FINAL DRAINAGE REPORT

LOT 1 & LOT 2 CROSSROADS MIXED USE FILING NO. 2 EL PASO COUNTY, COLORADO

Project #18-005
PCD Filing No.: PPR2311

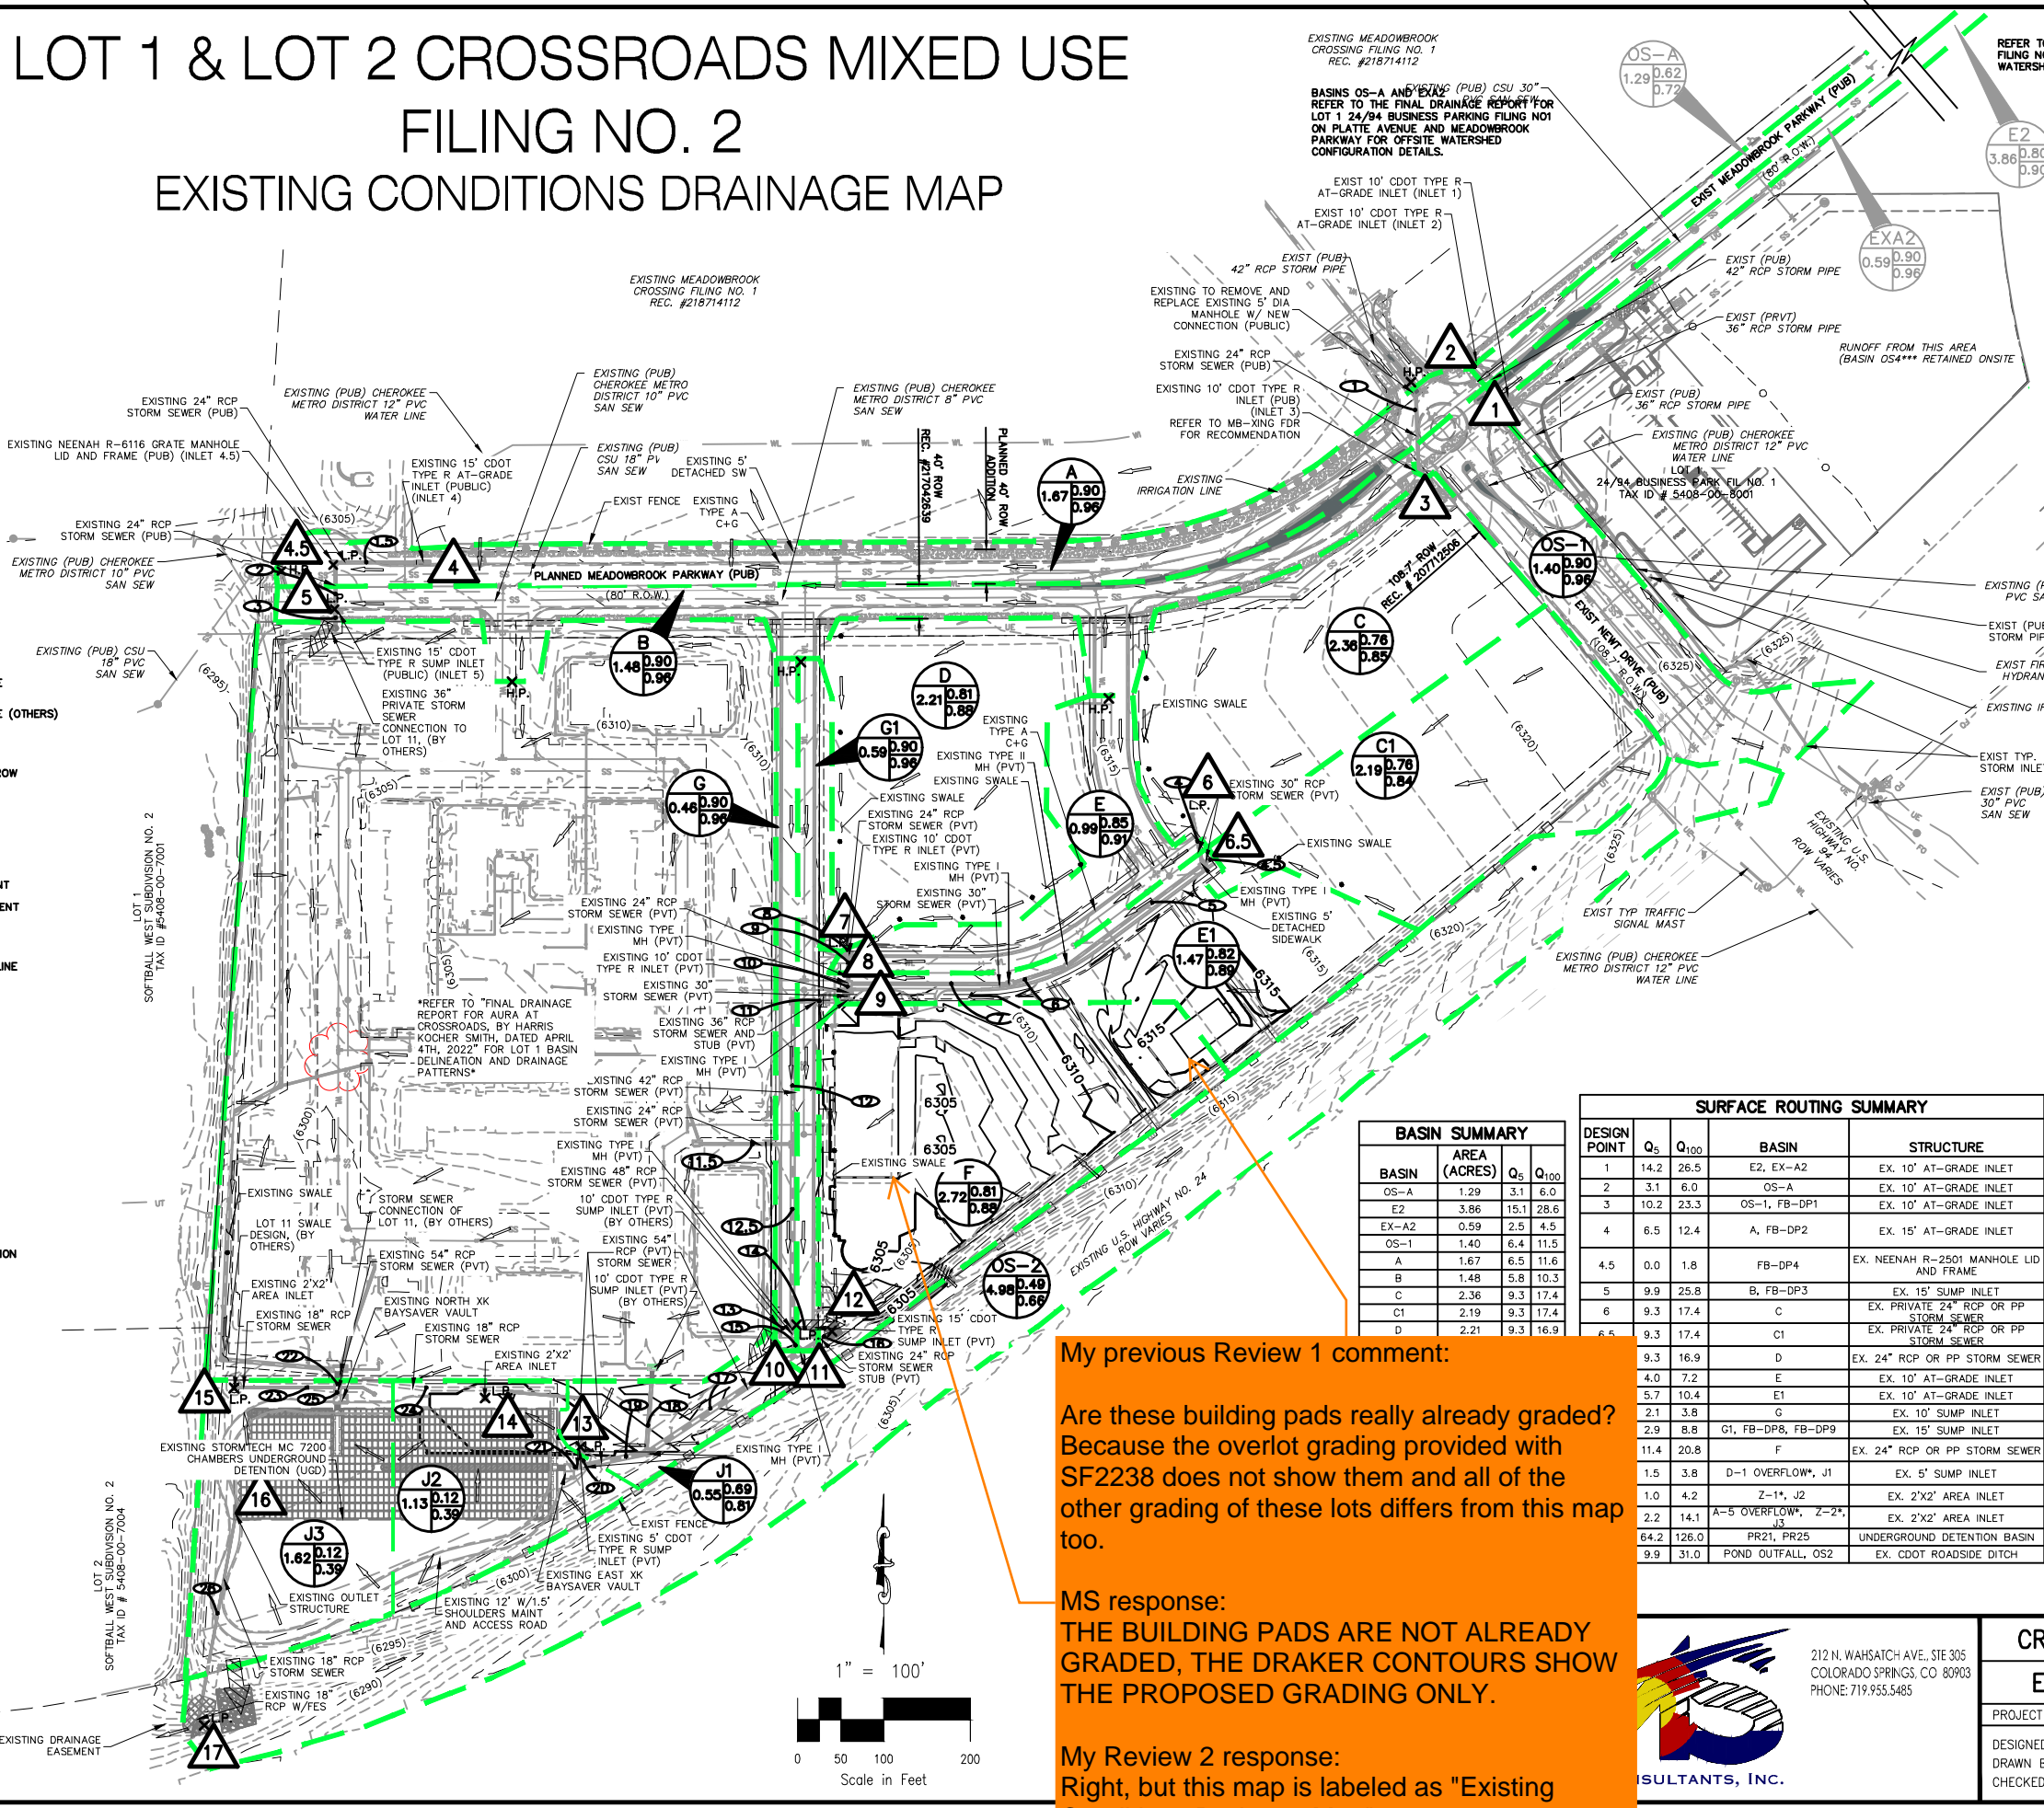
My previous Review 1 comment:
Are these building pads really already graded? Because the overlot grading provided with SF2238 does not show them and all of the other grading of these lots differs from this map too.

My Review 2 response:
Right, but this map is labeled as "Existing Conditions Drainage Map" so remove any proposed grading.

MS response:
THE BUILDING PADS ARE NOT ALREADY GRADED, THE DRAKER CONTOURS SHOW THE PROPOSED GRADING ONLY.

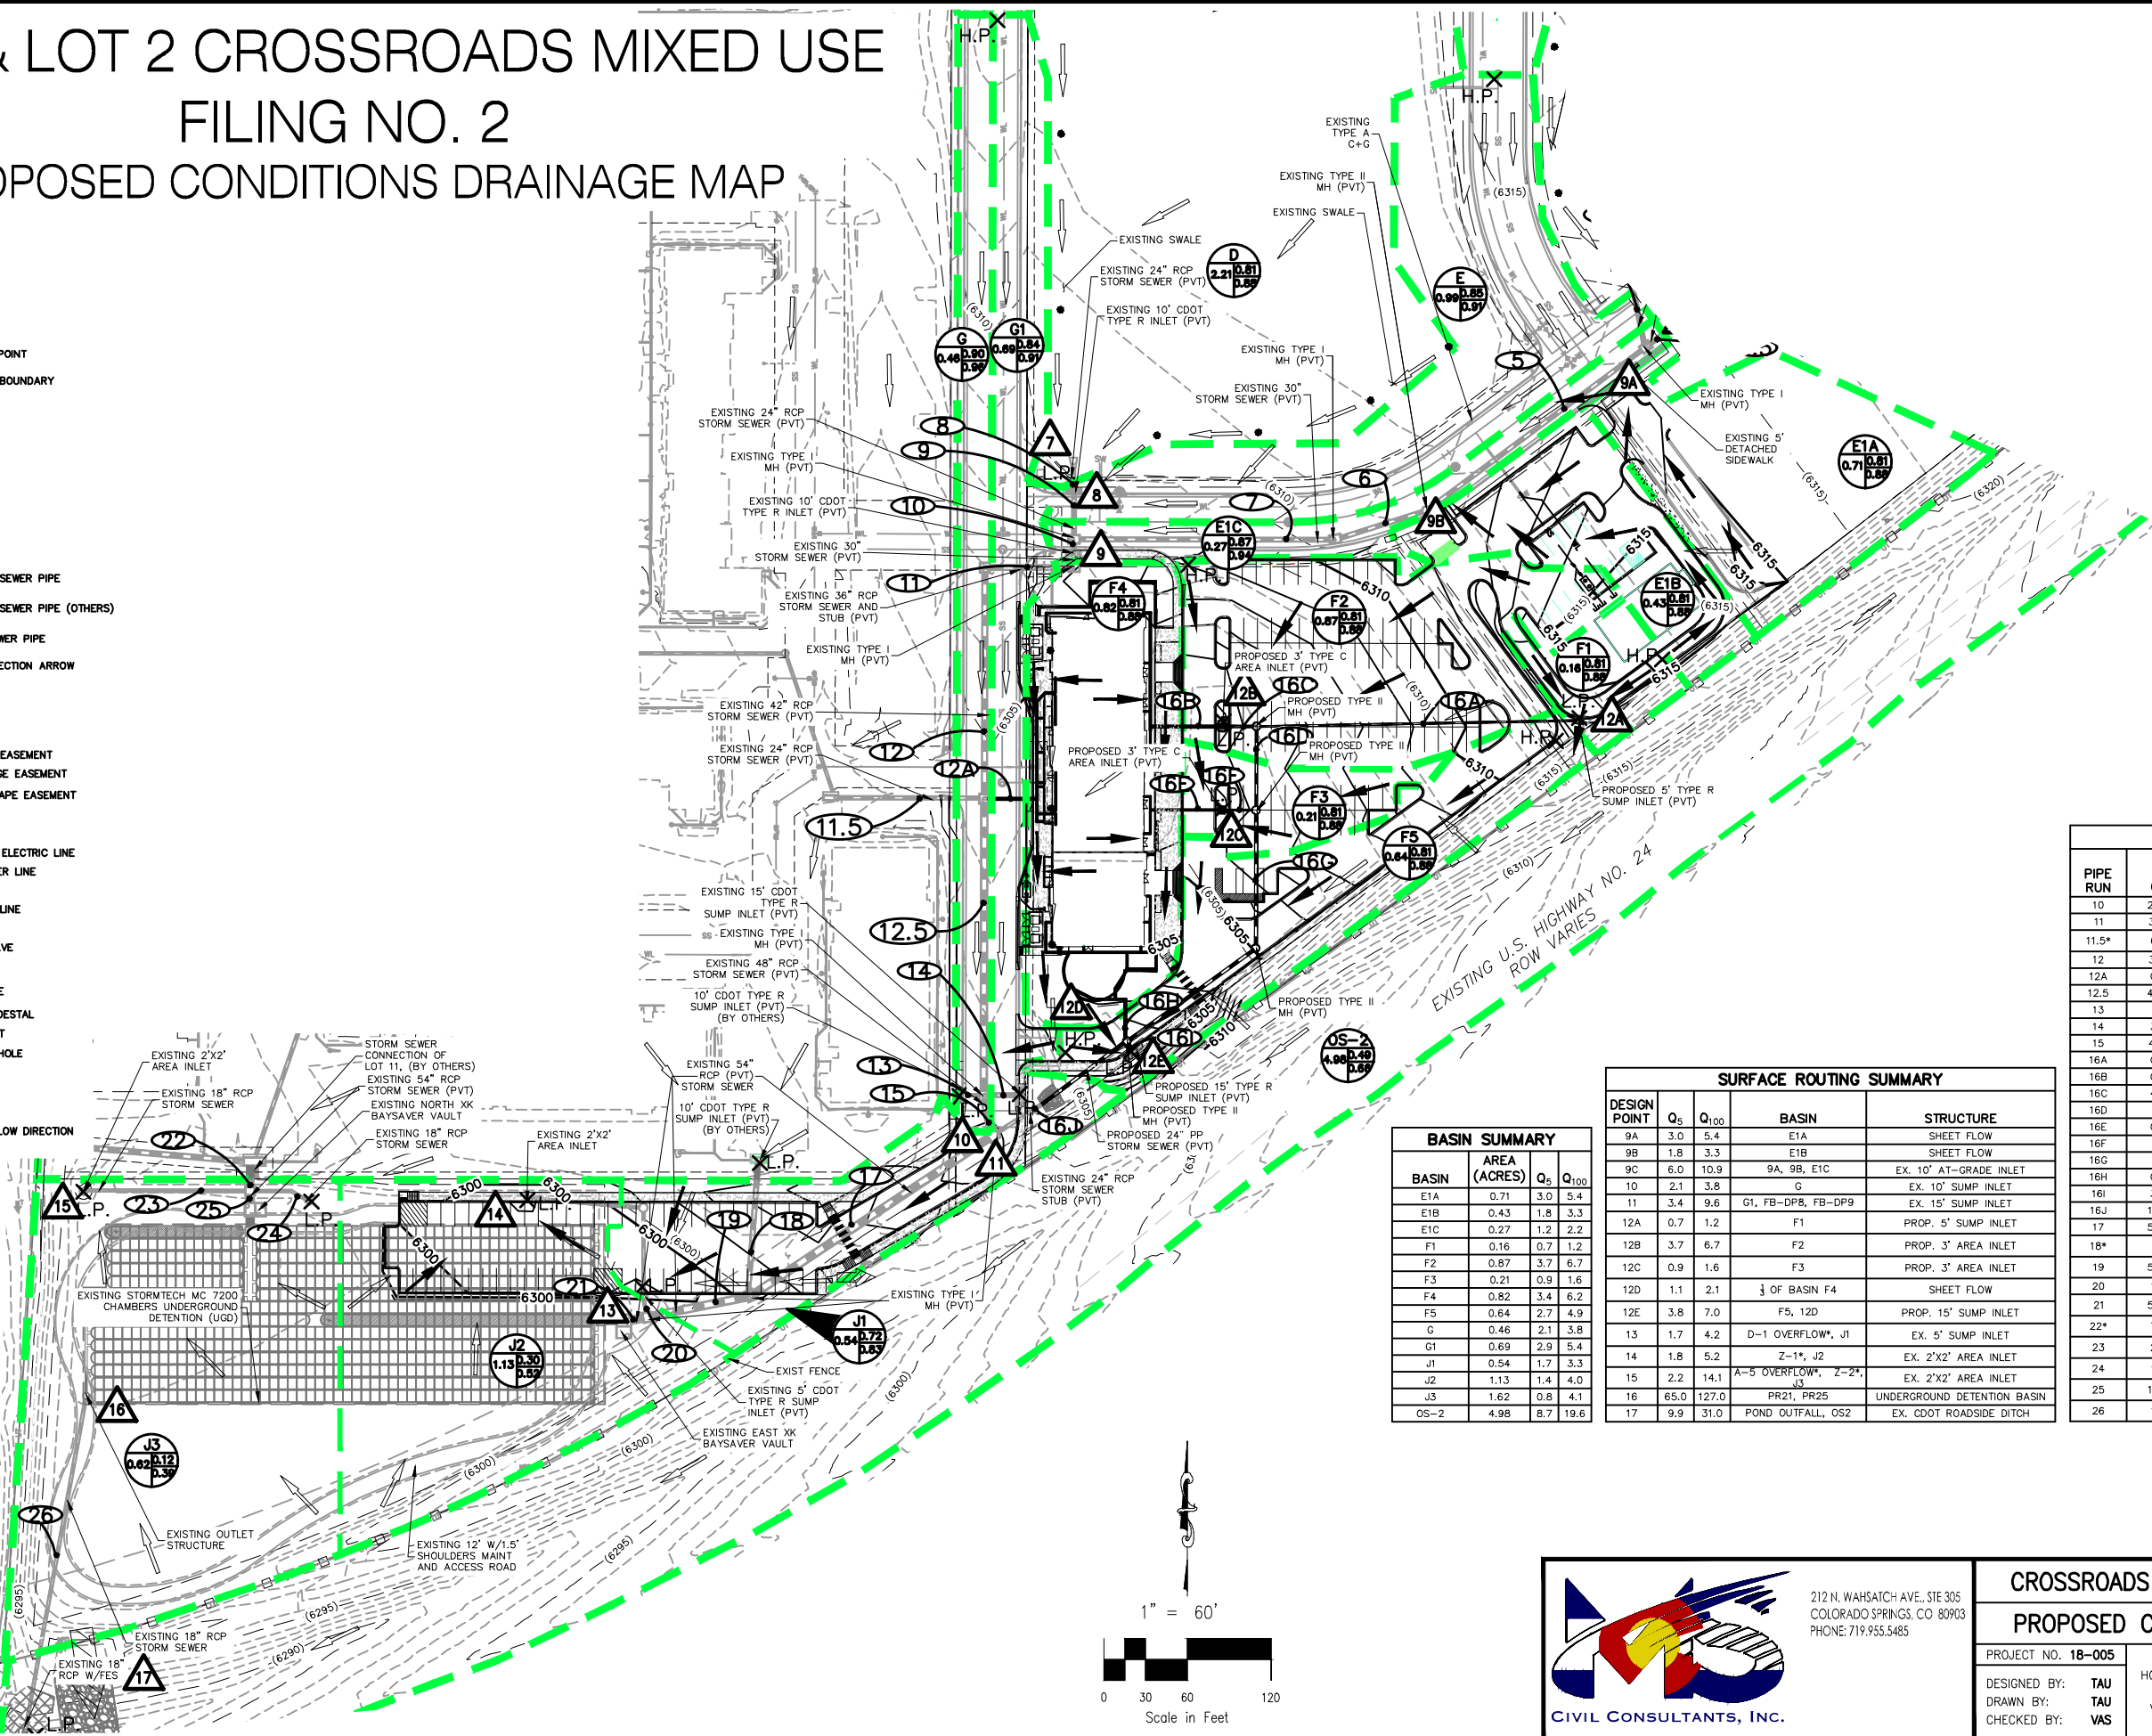
My previous Review 1 comment:

Are these building pads really already graded?
Because the overlot grading provided with SF2238 does not show them and all of the other grading of these lots differs from this map too.

My Review 2 response:

Right, but this map is labeled as "Existing Conditions Drainage Map" so remove any proposed grading.

MS response:

THE BUILDING PADS ARE NOT ALREADY GRADED, THE DRAKER CONTOURS SHOW THE PROPOSED GRADING ONLY.
